Device	XMC1200
Marking/Step	EES-AB, ES-AB, AB
Package	PG-TSSOP-16/28/38, PG-VQFN-24/40

Overview

This “Errata Sheet” describes product deviations with respect to the user documentation listed below.

Figure 1 Clock Selection Diagram for CCU4/CCU8

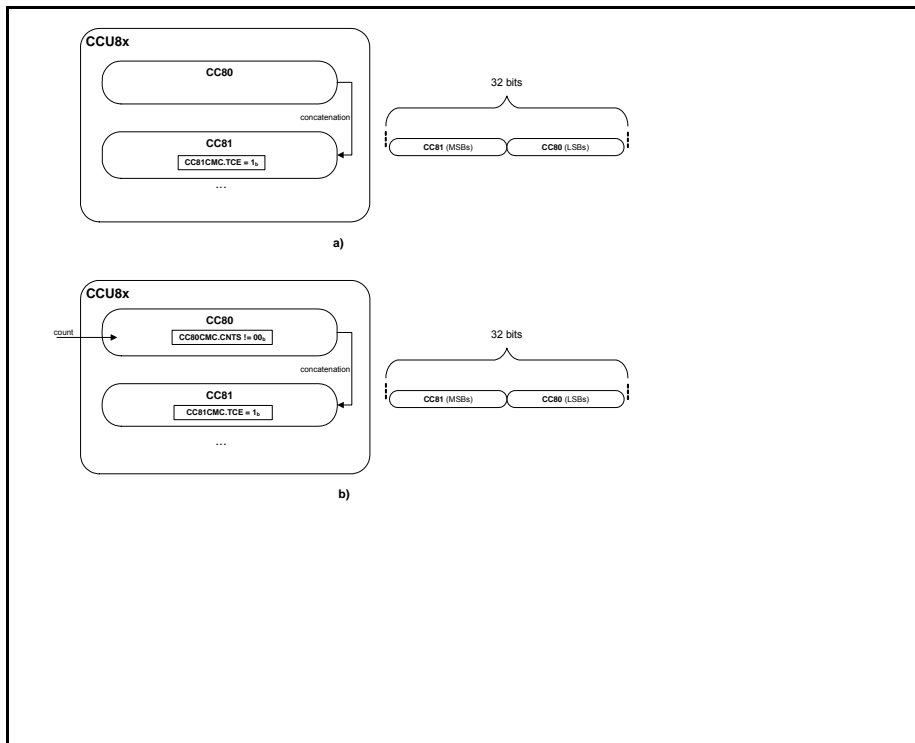
CCU_AI.005 CCU4 and CCU8 External IP clock Usage

Each CCU4/CCU8 module offers the possibility of selecting an external signal to be used as the master clock for every timer inside the module Figure 1. External signal in this context is understood as a signal connected to other module/IP or connected to the device ports.

Currently is only possible to use an external signal as Timer Clock when a division ratio of 2 or higher is selected. When no division is selected (divided by 1), the external signal cannot be used.

The user must program the PSIV field of each Timer Slice with a value different from 0000_B - minimum division value is /2.

This is only applicable if the Module Clock provided by the system (the normal default configuration and use case scenario) is not being used. In the case that the normal clock configured and programmed at system level is being used, there is not any type of constraints.

Workaround

None.
